ADDENDUM No. 2

Date **December 9, 2011**

Project Name Harold Court East Regional Service Center Improvements

C.I.P. No. 5700.012

BIOFILTRATION POND PLAN

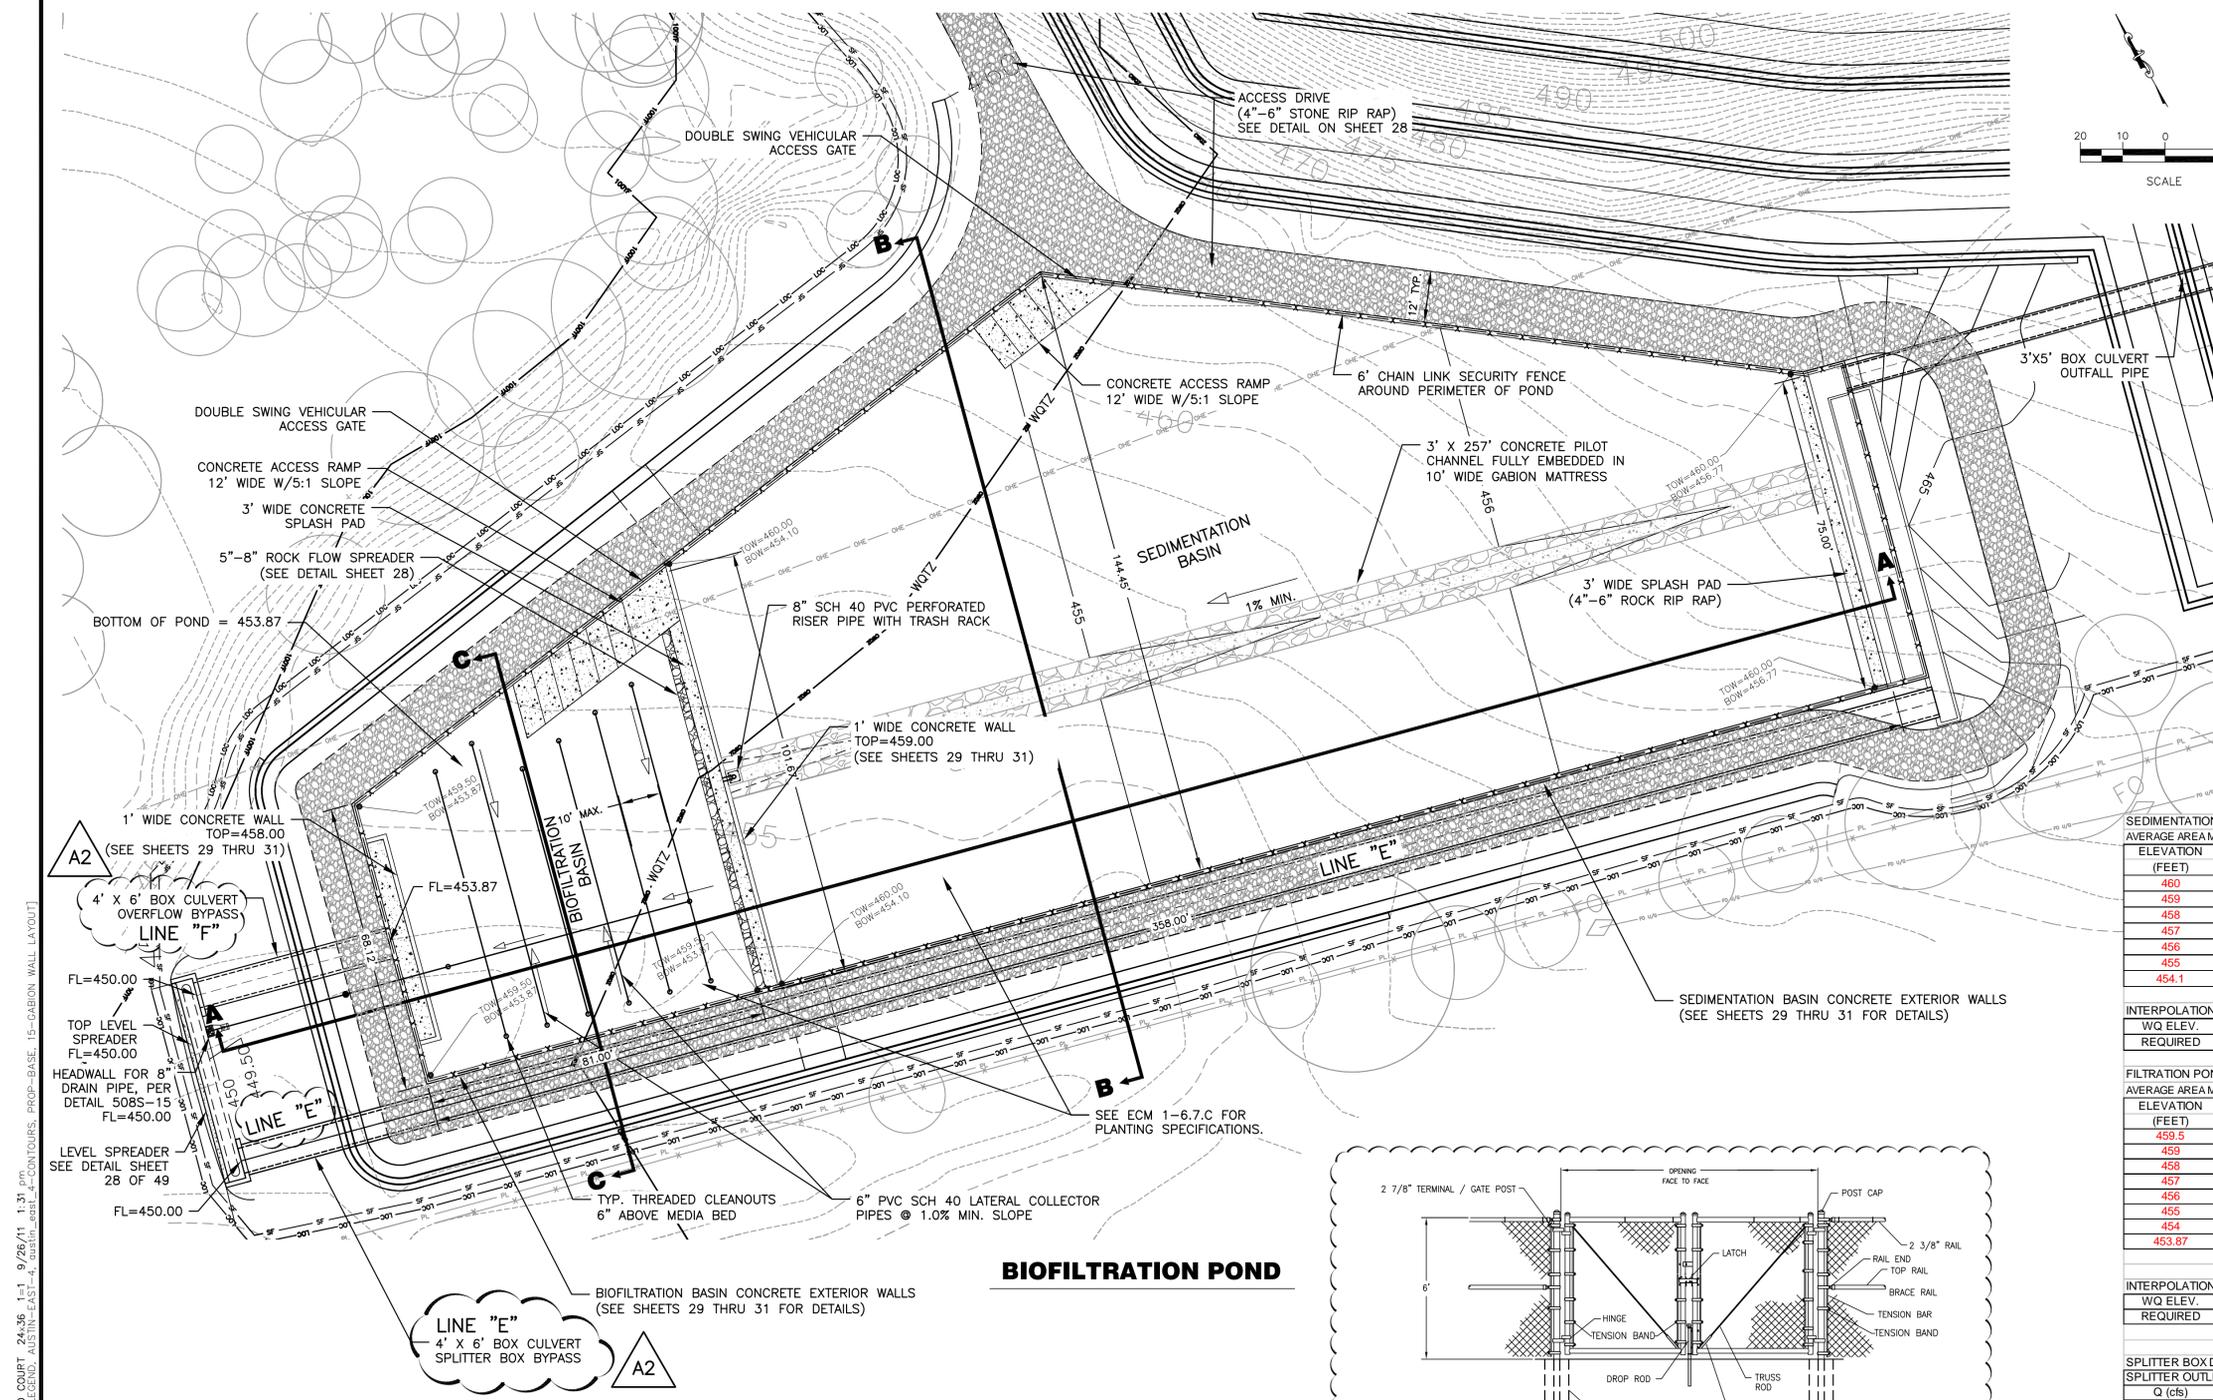
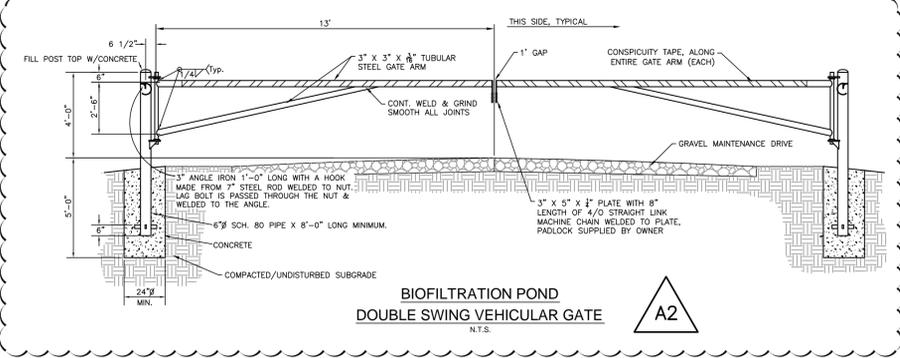
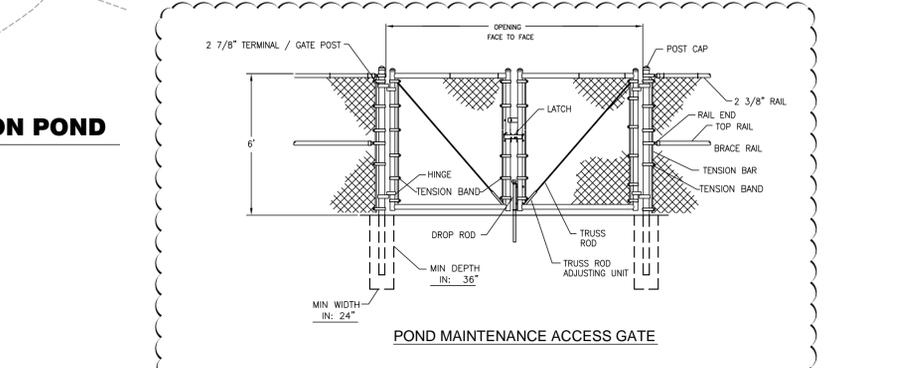
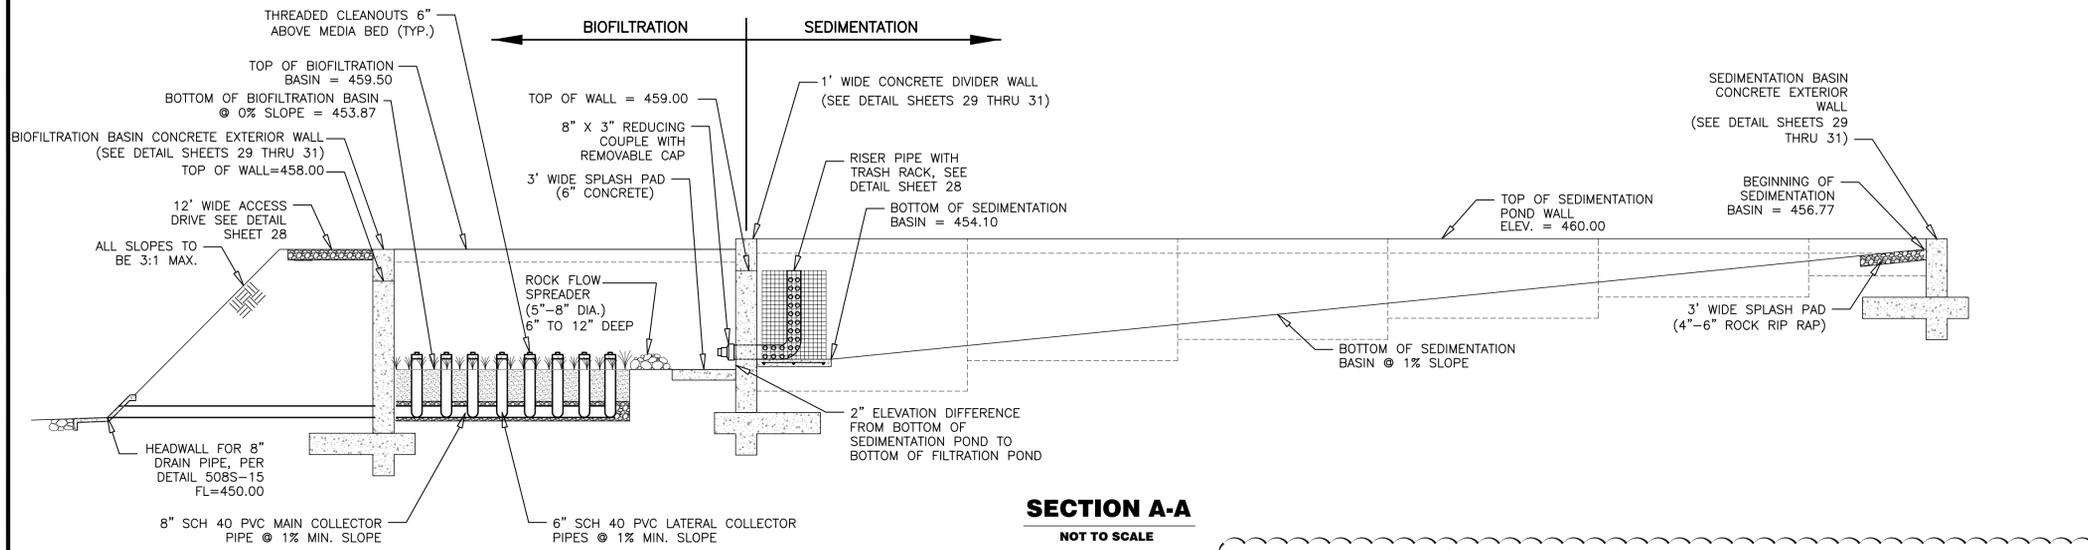
1. Delete Sheet 26, "Biofiltration Pond Plan," and replace with the attached, revised Sheet 26, "Biofiltration Pond Plan." Revised Sheet 26 provides labels for the box culverts attached to the biofiltration pond, and details for the access control gates to the biofiltration pond already shown on the approved plans.

CITY OF AUSTIN
EAST REGIONAL SERVICES CENTER IMPROVEMENTS
6101 1/2 HAROLD COURT, AUSTIN, TEXAS 78721
BIOFILTRATION POND CROSS SECTIONS

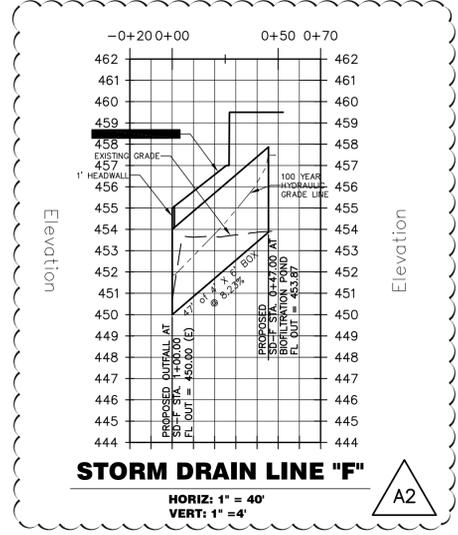
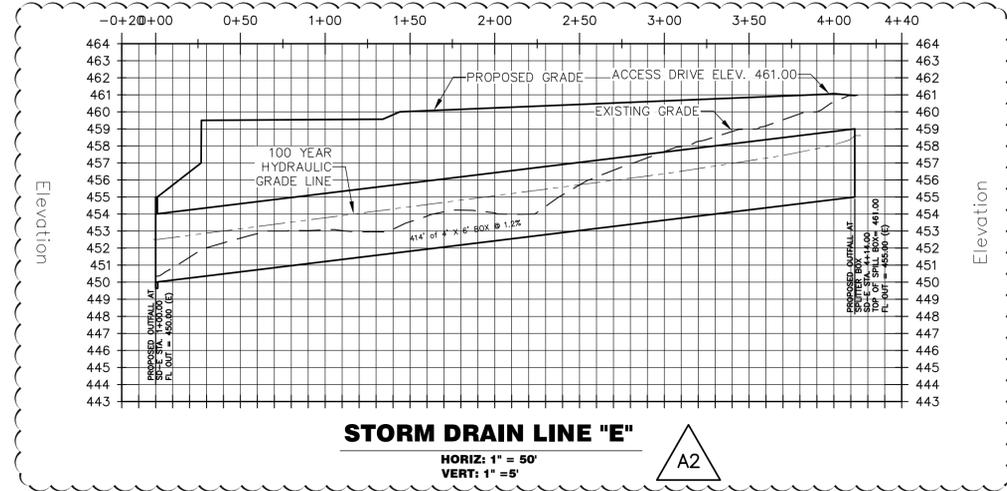
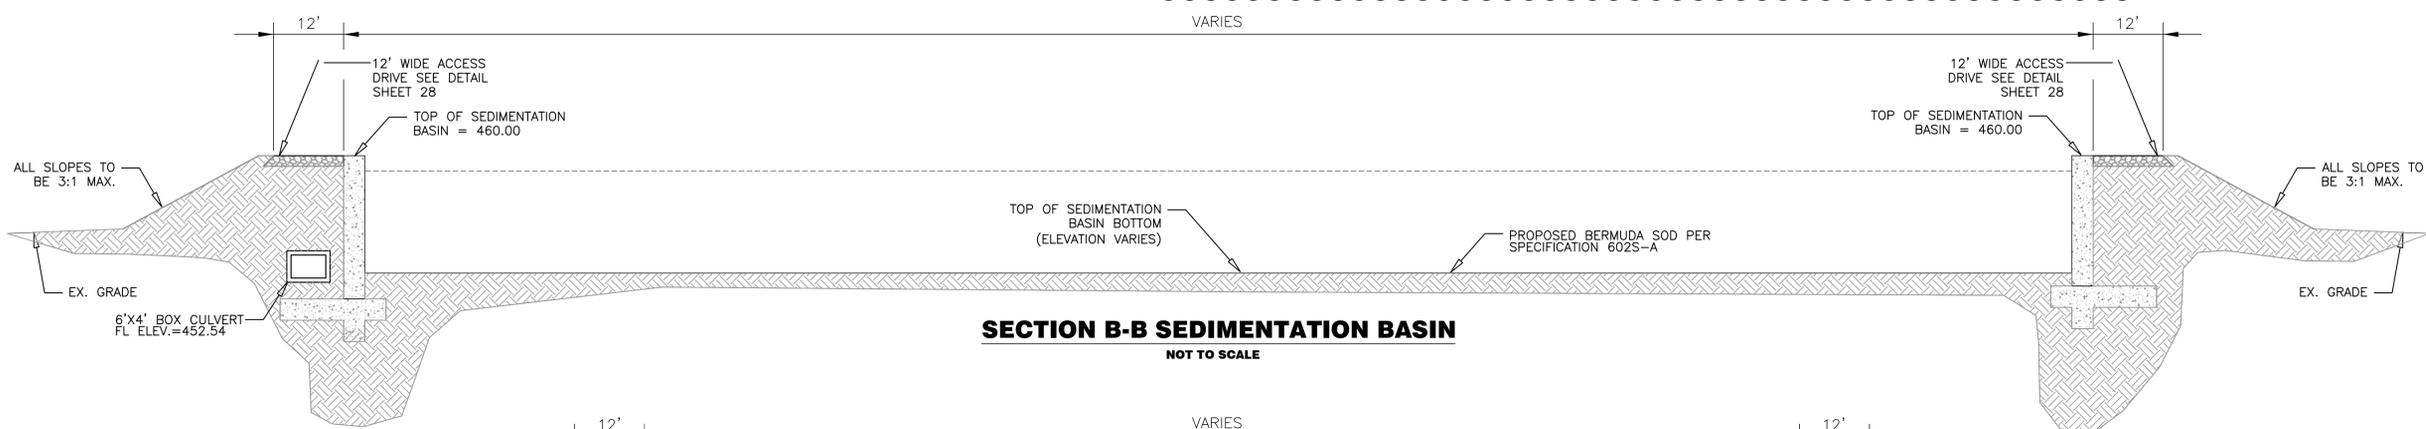
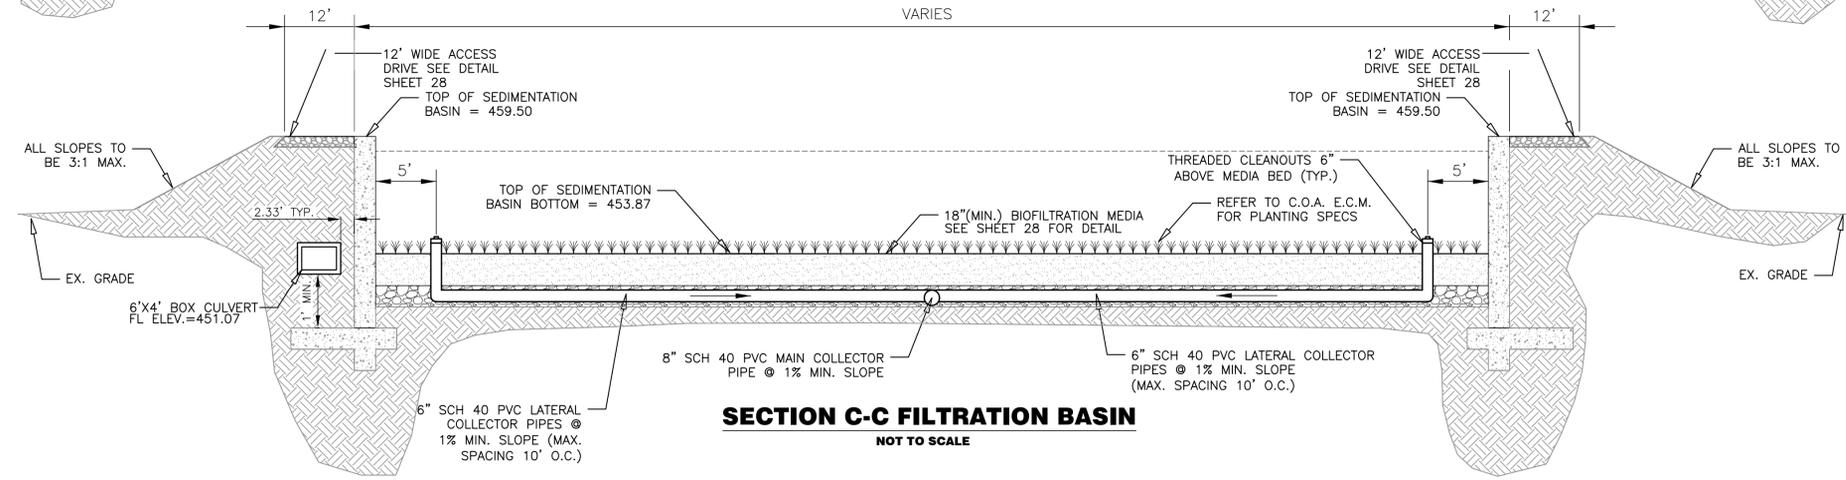
2. Delete Sheet 27, "Biofiltration Pond Cross Sections", and replace with the attached, revised Sheet 27, "Biofiltration Pond Cross Sections." Revised Sheet 27 provides profiles for the box culverts attached to the biofiltration pond already shown on the approved plans.

SITE PLAN RELEASE Sheet 28 of 49

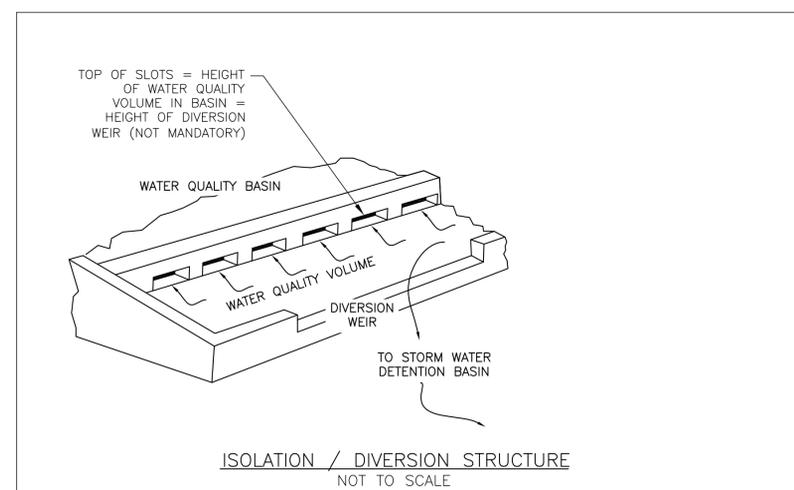
3. Delete Sheet 28, "Biofiltration Pond Details," and replace with the attached, revised Sheet 28, "Biofiltration Pond Details." Revised Sheet 28 provides a detail for the revetment mattress in the biofiltration pond already shown on the approved plans.

BIOFILTRATION POND WALL
SECTIONS AND DETAILS

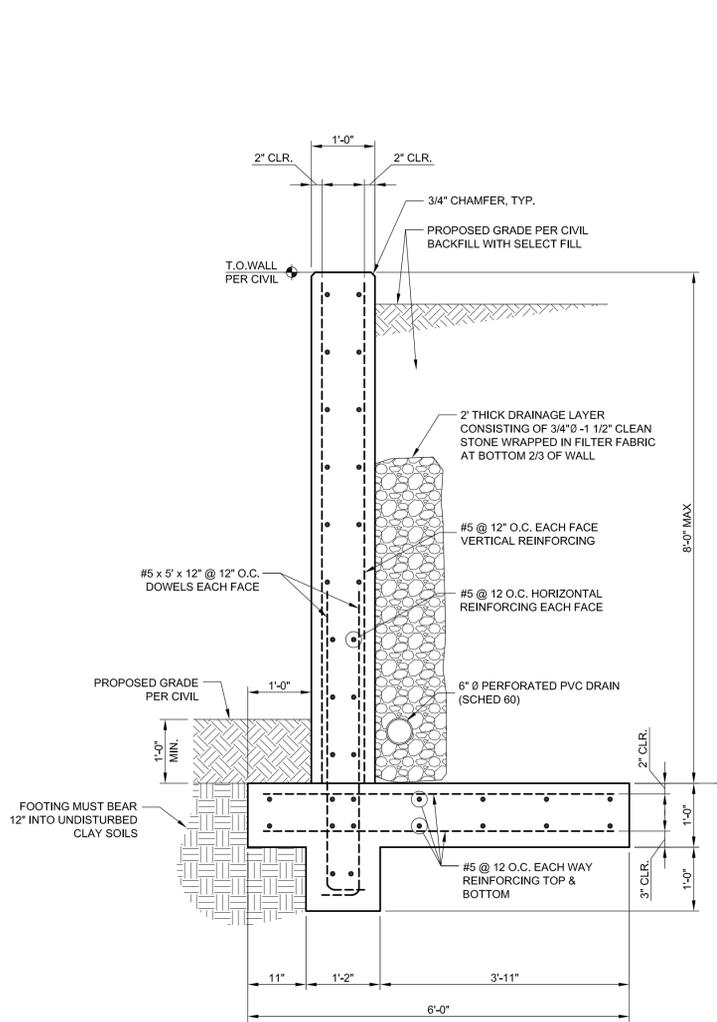
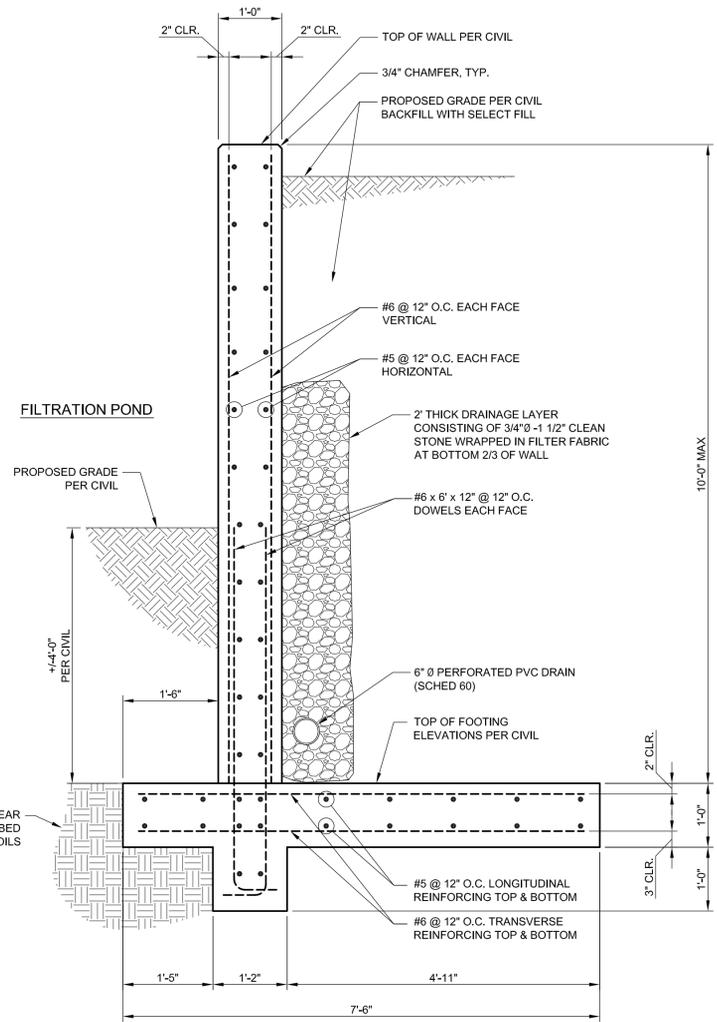
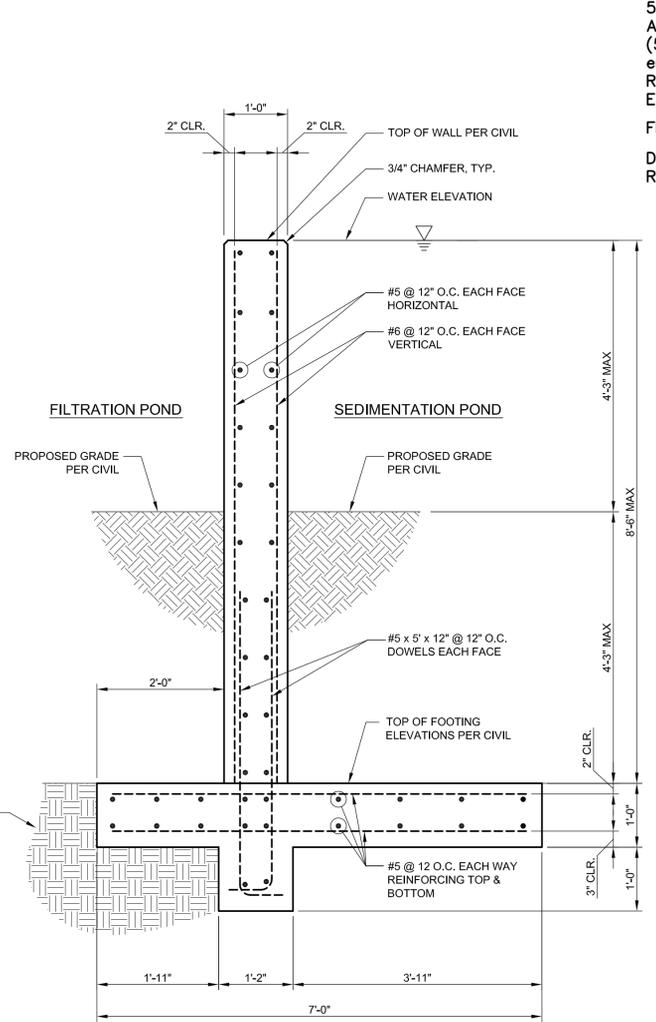
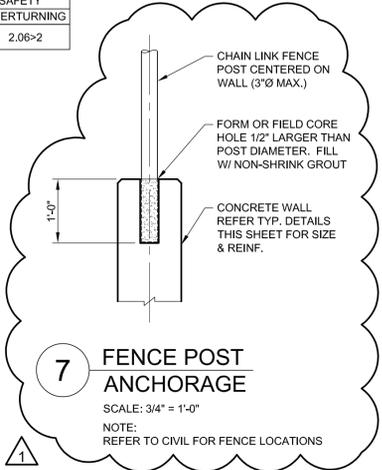
4. Delete Sheet 31, "Biofiltration Pond Wall Sections and Details", and replace with the attached, revised Sheet 31, "Biofiltration Pond Wall Sections and Details". Revised Sheet 31 provides a detail for the installation of the fence posts on top of the biofiltration pond wall already shown on the approved plans.
